STEMCO TrailerTail® AutoDeploy™ Electric Latch Sealant

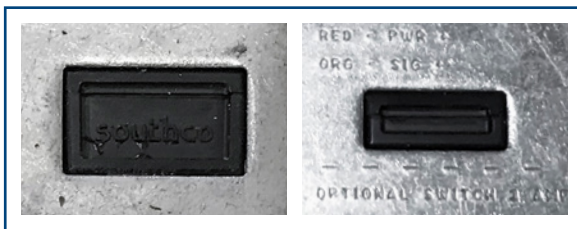
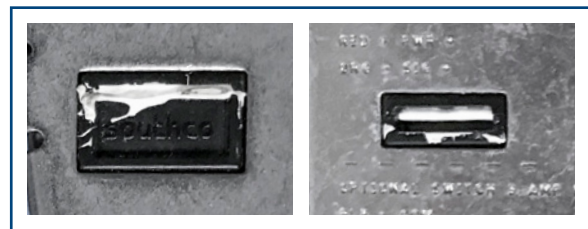
In 2014 STEMCO released a new AutoDeploy™ electric latch with an enhanced latch motor sealing system. We had seen a few returns of electric latches with moisture in the motor and wanted to ensure our customers were receiving the highest quality and most durable product. If you have a failed latch with the older sealing system, we simplify the warranty process by only requesting photos of the latch to verify that no white sealant is present. We do not require returning these old latches to STEMCO for warranty approval.

The images below show how to identify the old latch revision from the new. The latch motor is exposed through two windows in the latch case. If you can see a white line in either of those windows, then the latch is a new revision and must be returned to STEMCO to undergo testing prior to being approved for warranty.
